Township of Guelph/Eramosa Traffic Impact Study Review Document Book

Traffic Impact Study Review Document Book Index

**Re: ZBA Hidden Quarry – Township of Guelph/Eramosa
James Dick Construction
File No.: 300032475.0000**

**Re: Response to R.J. Burnside & Associates Limited comments dated January 11, 2013 for
Eramosa Quarry - Traffic Impact and Parking Study
Town of Guelph-Eramosa**

Figure 1 – Future (2022) Total Traffic Volumes

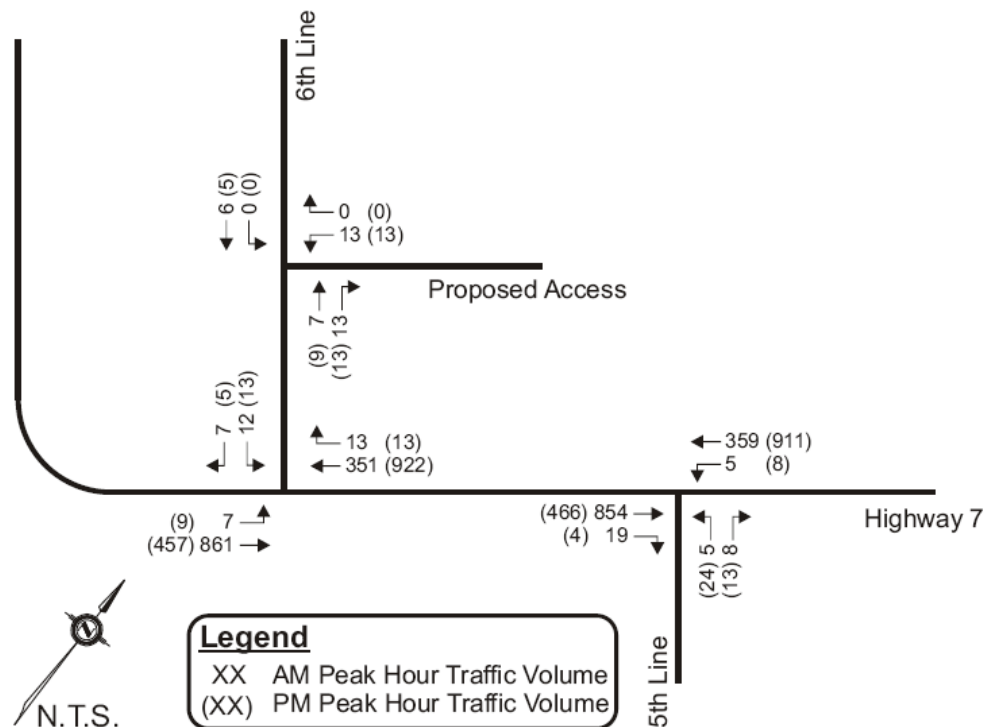
Comment # 4:

Based on MTO’s 2008 Seasonal Variation curves, the through traffic volumes along Highway 7 (commuter road) were adjusted to the summer seasonal peak. In this instance, the peak summer month was July with through volumes adjusted by a factor of 1.33. The adjusted traffic volumes for the future (2022) total traffic horizon as shown in **Figure 1**.

The adjusted traffic volumes were analysed using Synchro 6.0 software and the results are summarized in **Table 1**.

Figure 1 Highway 7 / 5th Line Left Turn Warrant

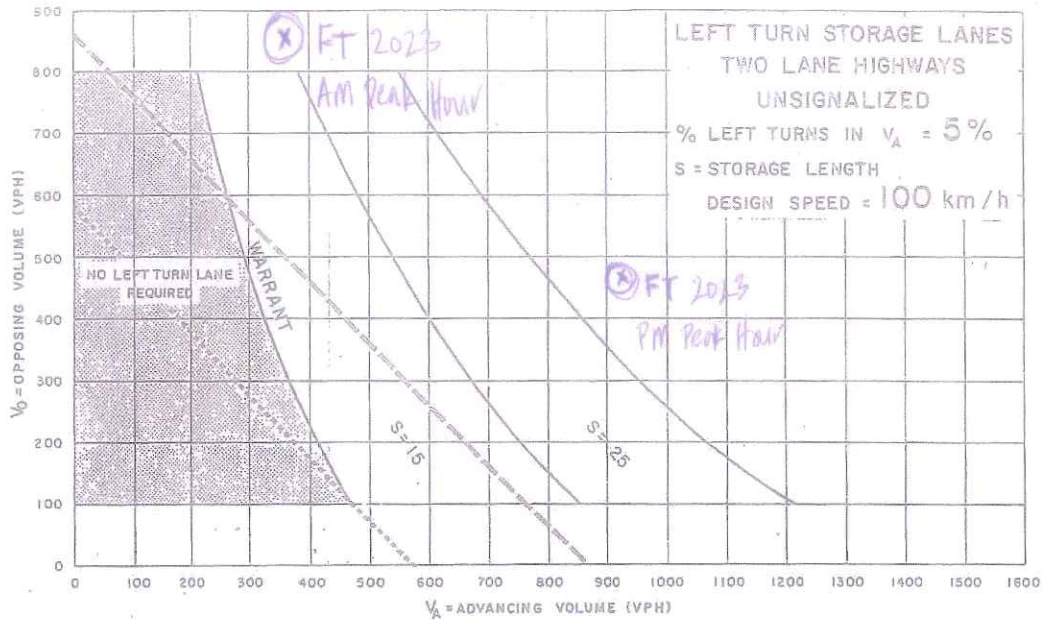
Comment 4 of the R.J. Burnside letter requests that a left turn warrant be undertaken at the 5th Line / Highway 7 intersection for the westbound left turn manoeuvre. Therefore, using the future (2023) total traffic volumes in the *Revised Traffic Impact Study*, the left turn warrant was undertaken. The completed warrant is provided in **Figure 1** for reference.

Based on the warrant, a westbound left turn lane is required for the 5th Line / Highway 7 intersection during both the a.m. and p.m. peak periods in excess of 25 meters. This is due to background development traffic as traffic from the Eramosa Quarry will not be making the westbound left turn onto 5th Line since it is not a designated truck route.

Using the *Geometric Design Standards for Ontario Highways* published by the Ministry of Transportation of Ontario (MTO), the westbound left turn lane at the 5th Line / Highway 7 intersection requires 160 meters of taper and 70 meters of parallel lane for deceleration, as well as 25 meters of storage. The left turn lane will require a runout lane which is the same length as the deceleration lane requirements. Due to the proximity of the 6th Line / Highway 7 intersection, the runout lanes from each intersection are expected to encroach. As a result, it is recommended that a center lane be maintained to facilitate the runout between each intersection.
